NAVION SERVICE LETTER # 87  
FEBRUARY 20, 1965

MANDATORY

SUBJECT: Fuel Accumulator Tank - Replacement  
EFFECTIVITY: All Model Navions  
REFERENCE: Ryan Service Letter #78  
DRAWING: Tanks experienced corrosion - Item #2307 - P/N 145-48004  
Replacement Tanks - Item #2307-10 P/N 145-48006

FUEL SYSTEM ACCUMULATOR TANK MAINTENANCE AND MODIFICATION

Figure 1 - Accumulator Tank Bracket

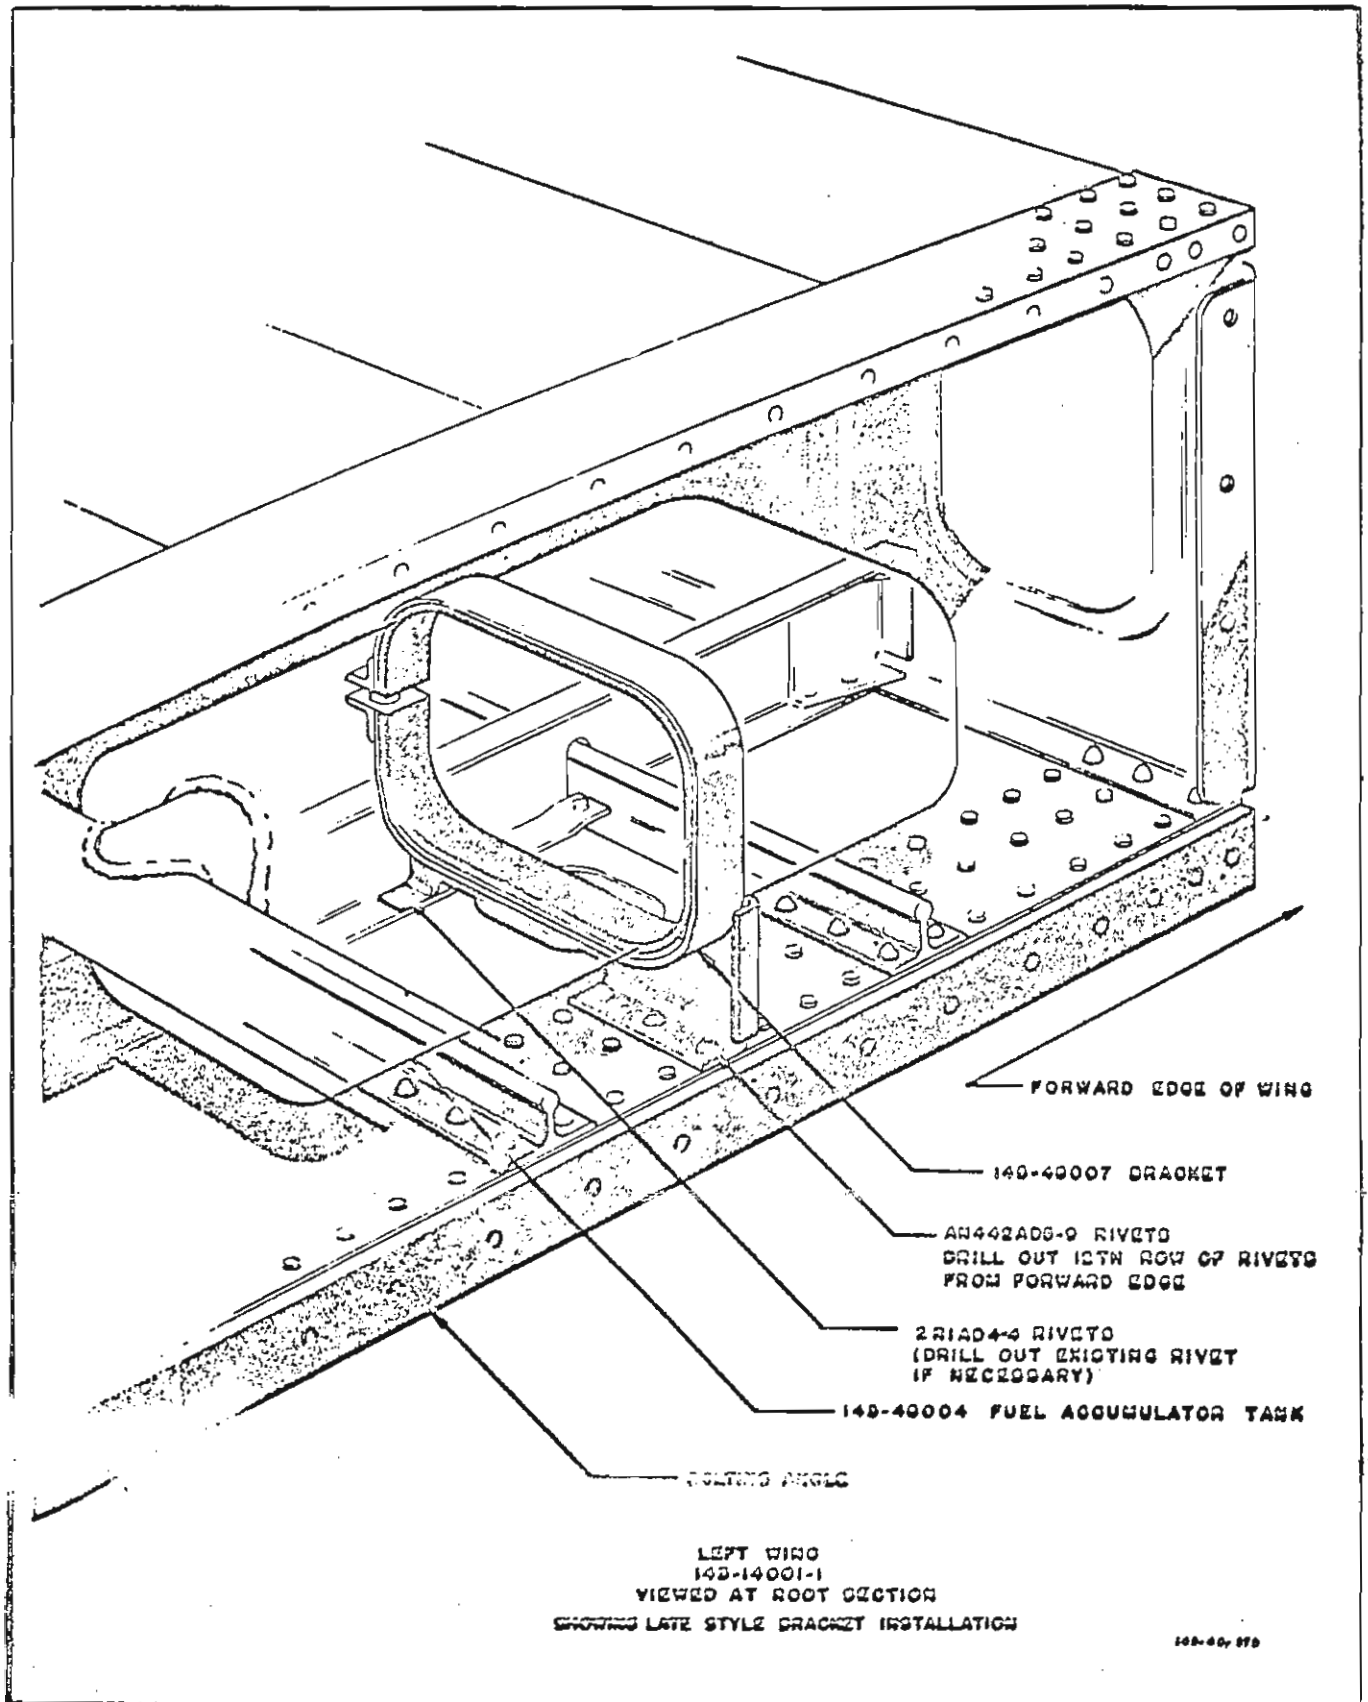
Navion airplanes prior to factory serial number NAV-4-1251 have the fuel accumulator tank supported by two 145-48008 brackets riveted to the 143-14010-20 center rib. Airplanes subsequent to NAV-4-1251 have the fuel accumulator tank supported by one 145-48007 bracket, riveted to the bolting angle of the left wing.

1. Inspect inside the root section to see if fuel accumulator tank bracket 145-48007 is installed. If the 145-48007 bracket is installed, remove it from the wing as follows:
  - a. Drill out the three AN442AD5-9 rivets which attach one end of 145-48007 bracket to the wing bolting angle. This is the 12th row of rivets aft of forward edge of the wing.
  - b. Drill out one 2R1AD4-4 rivet attaching the outboard end of the 145-48007 bracket, and remove bracket from wing.
  - c. Replace the first three removed rivets with AN442AD5-9 rivets. Replace the removed outboard rivet with one 2R1AD4-3 rivet.

1. Inspect the inside root section of left wing to see if the 145-48007 fuel accumulator tank bracket is installed. If bracket is not present, install the new 145-48007 bracket, received as a loose part, as follows:
  - a. Drill out three AN442AD5-8 rivets which run spanwise in the bolting angle. This is the 12th row of rivets aft of the forward edge of wing.
  - b. Clamp 145-48007 bracket in the wing with the flange of bracket over holes just drilled. Drill through bolting angle holes and bracket flange with a No. 21 (.159) drill.

CAUTION: Do not elongate holes in bolting angle.
  - c. Attach bracket to bolt angle with three AN442AD5-9 rivets.
  - d. Drill through rib, wing skin, and pilot hole on outboard flange of bracket with No. 30 (.128) drill, and install one 2R1AD4-4 rivet.
